Product Advisory

Product Family: CFW320 VFDs
Part Numbers: See below
Subject: Incorrect wiring label

Number: PA-GS-024
Date Issued: 07/20/2026
Revision: Original

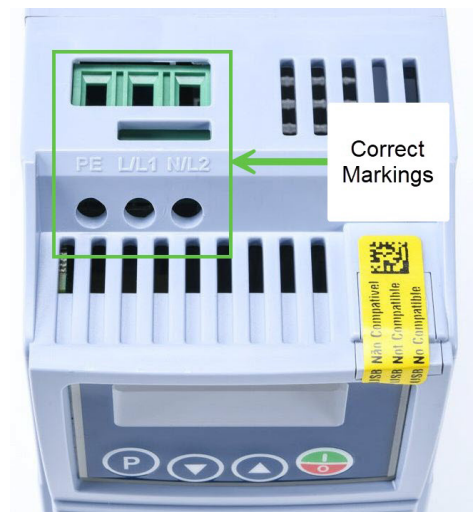
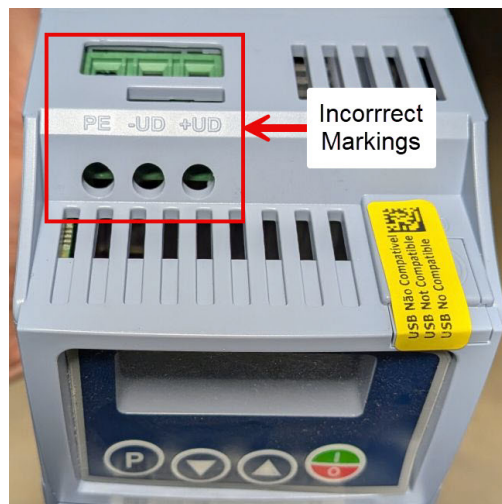
Certain CFW320 single phase AC drive models were manufactured with a molded plastic part from DC drive versions. That plastic part is embossed with incorrect Input Wiring terminal identification markings.

These drives have the three Input Wiring terminals identified as: PE, -UD and +UD. Those are the indications for DC power input and are incorrect. The correct Input Wiring terminal identifications are: PE, L/L1 and N/L2.

Customers should open all cartons that match the part number and date code and inspect the Input Wiring identifications. **Do not use the incorrectly marked drives.** Contact AutomationDirect.com technical support for drive replacement.
